**Re: Response to Council Request for Further Information
Planning Permit No. GE/DPNO-18701/2021
31 Station Street, Caulfield East – Stage 9**

1.0 RESPONSE TO COUNCIL REQUEST FOR FURTHER INFORMATION

The Boulevard Section - Excerpt from drawing SD06_W_23

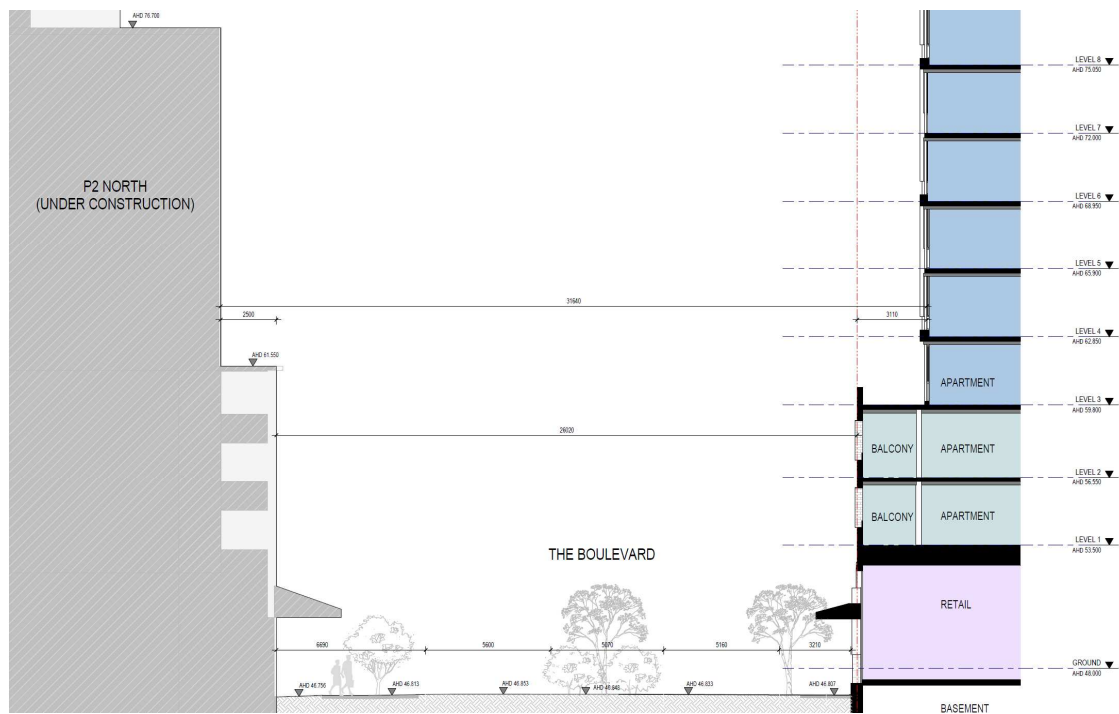
- *The proposed building envelope would not comply with the Caulfield Village incorporated plan – there would be insufficient differentiation between the podium and tower forms. The towers would be overly dominant and discordant elements in the streetscapes, particularly to the south.*
- *The southern tower form should be set back a greater amount from the southern and eastern boundaries, to provide a greater differentiation between tower and podium forms, more closely aligned with the Incorporated Plan.*
- *The proposed form of the towers would read better if they had a base/middle and top with additional architectural interest. It is also suggested that the top two levels be recessed further than the levels below.*

Specifically with regard to the southern setback to Station Street, the supporting statement prepared by SJB Architects outlines how the design approach is in response to the 57.8-metre-wide roadway and the '...vastness of the Caulfield Racecourse' to the south (drawing SD06_W_24 within Appendix I).

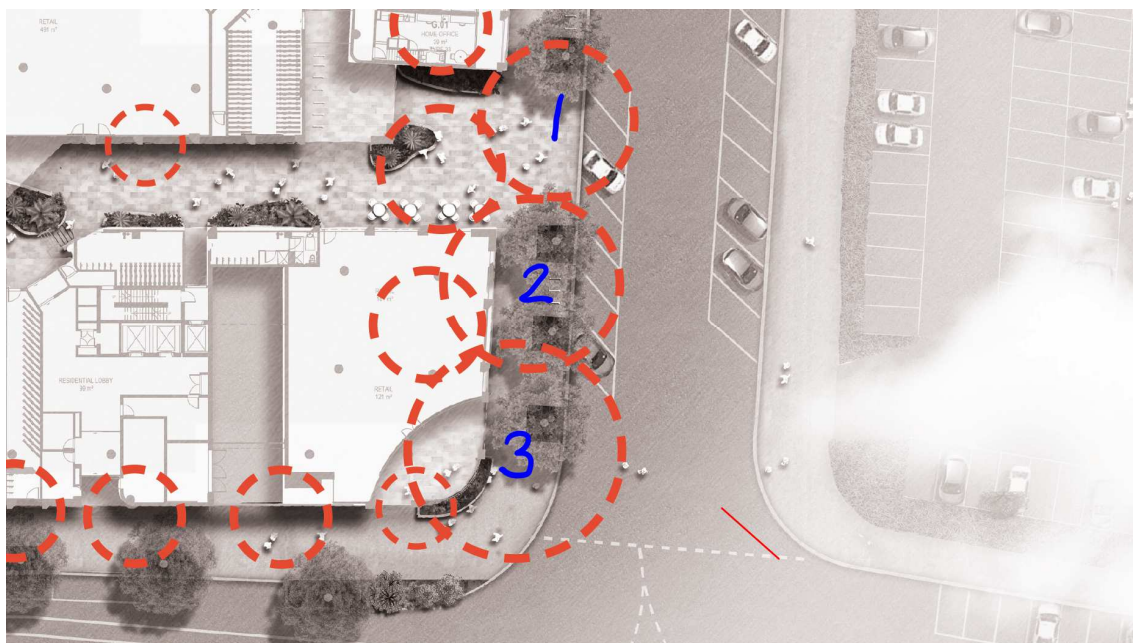
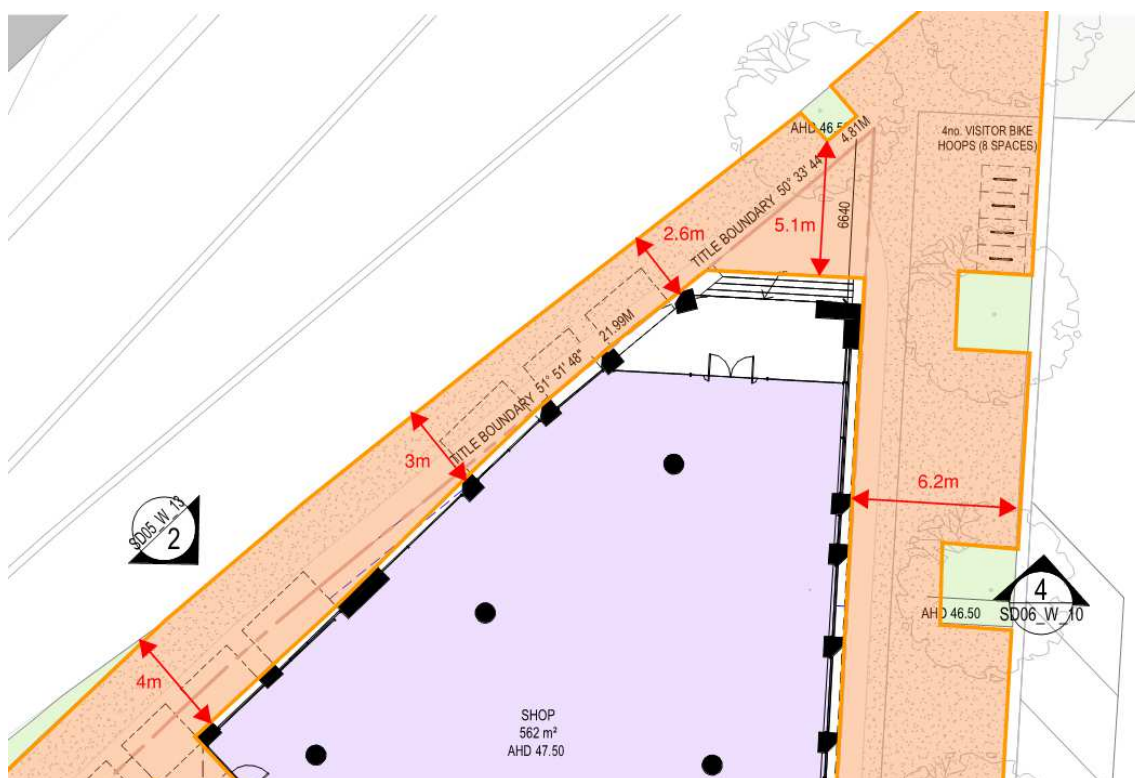
- j) Council has concerns about the proposed removal of established street trees in Smith Street. Smith Street should become a shared space/green space. There is a potential that the landscape throughout the space will be less regimented than shown in the submitted drawings.

Additional clarification is required in relation to the proposed removal of street trees. Whilst this may be supported (subject to clarification/approval from Council's Parks Services Department), robust justification should be provided for any proposed removal, including the provision of a replanting scheme which will offer comparable/improved contribution.

More appropriate species and a wholistic, curated landscape vision will produce a superior outcome for the long-term success of the Caulfield Village precinct.

Figure 2: Location of Pedestrian Crossing

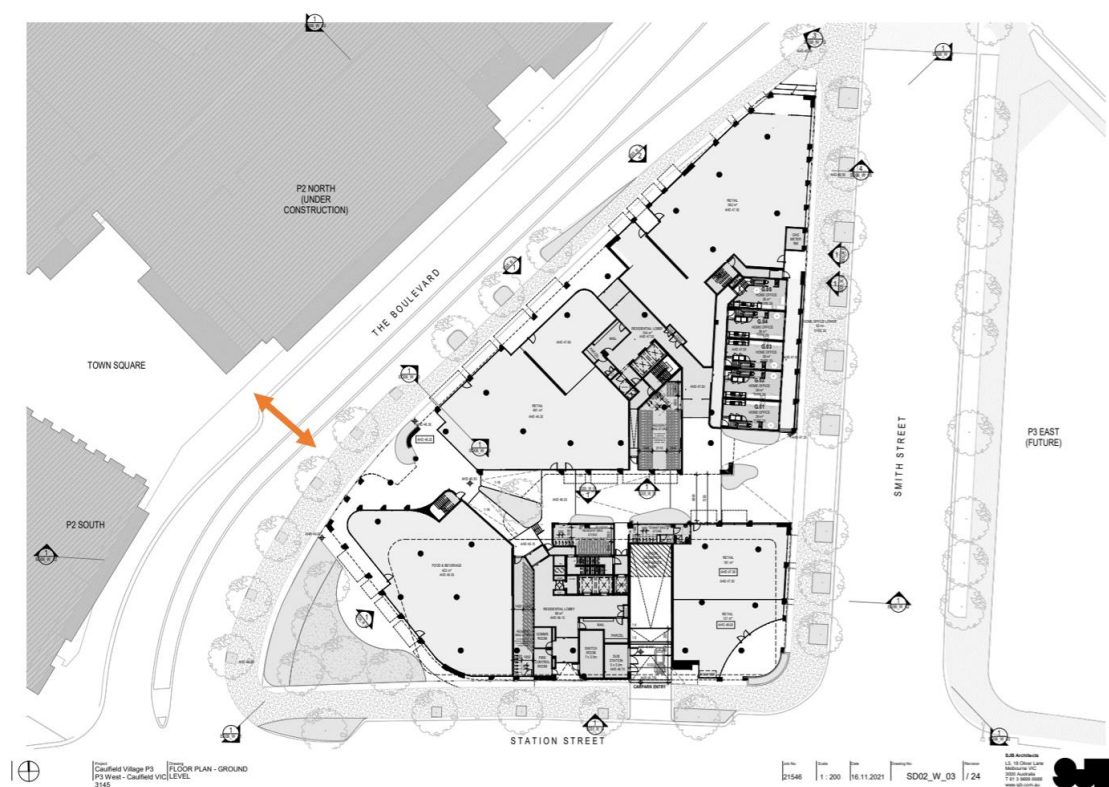
4. <i>A Road Safety Audit is to be provided, including all relevant information to provide assessment of areas of potential conflict, and to clarify any modifications required to ensure the safe operation of the network.</i>	<p>As agreed with Council, a Road Safety Review (as opposed to a Road Safety Audit) is enclosed as part of the Traffic Engineering Response prepared by Stantec.</p> <p>The Road Safety Review addresses areas of potential conflict and modifications to ensure the safe operation of the network (a pedestrian crossing across The Boulevard).</p>

A pedestrian crossing has been detailed within the submitted Traffic Engineering Response prepared by Stantec.

Additional detail will be provided in regard to the specifics of the pedestrian crossing when a design is prepared. Given the proximity to the signalised intersection with The Boulevard to the south, it is expected that a zebra crossing is the most appropriate pedestrian crossing treatment. This can be provided as a raised zebra, similar to the arrangement shown in Figure 3. Noting that this will be a Council asset, the Applicant is happy to work with Council to determine the most appropriate pedestrian crossing treatment to Council's satisfaction.
